THE PROBLEM SOLVER®

Lower Ball Joint Failure

**MOOG® Problem Solver®
K7467 Lower Ball Joint**

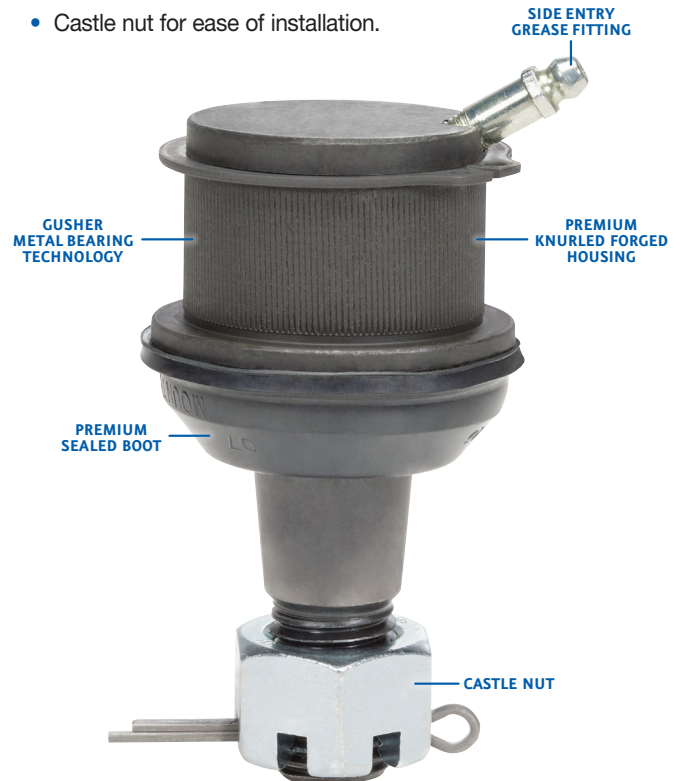
OE and other suppliers' designs can lead to early failure in vehicles that are subject to adverse road conditions or severe duty use.

- Plastic bearing is subject to excessive wear.
- No provision for preload can lead to excessive deflection and degradation of socket torque as the bearing wears.
- OE ball joint is non-greaseable, and the tight installation clearance makes servicing other suppliers' ball joints difficult.

The MOOG® Problem Solver® K7467 ball joint features many improvements over the OE and other suppliers' ball joints.

- Exclusive powdered-metal "gusher" bearing improves wear resistance and durability.
- Belleville washer ensures proper preload and consistent socket torque for the life of the part.
- Premium knurled housing ensures strength and a secure installation.
- Premium black polychloroprene boot lasts longer than blue neoprene boots.
- Side-entry style grease fitting allows easy service of ball joint while on vehicle.
- Castle nut for ease of installation.
